# SERVICE BULLETIN #124

04/14/14

## 3562 Spoke Wheel

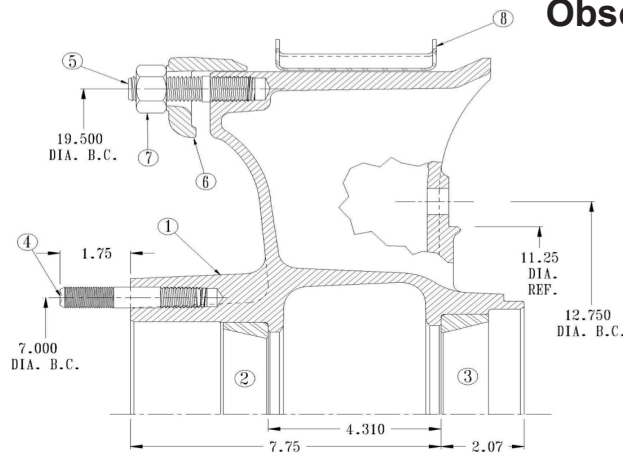
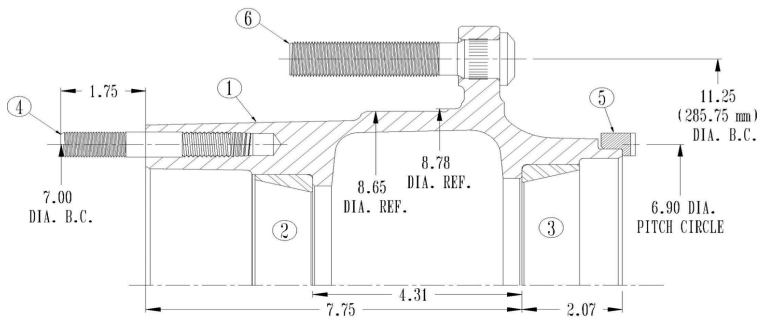
Upon depletion of inventory, the 3562 spoke will become obsolete with no direct replacement. We do however recommend a replacement: the 10-stud 2643 hub. This requires changing brake drums, changing to a disc hub, and changing to disc wheels instead of demountable rims. If you have any questions, please contact the Webb Engineering department via email to [engineering@webbwheel.com](mailto:engineering@webbwheel.com) or call 256-736-6356.

### Replacement Option
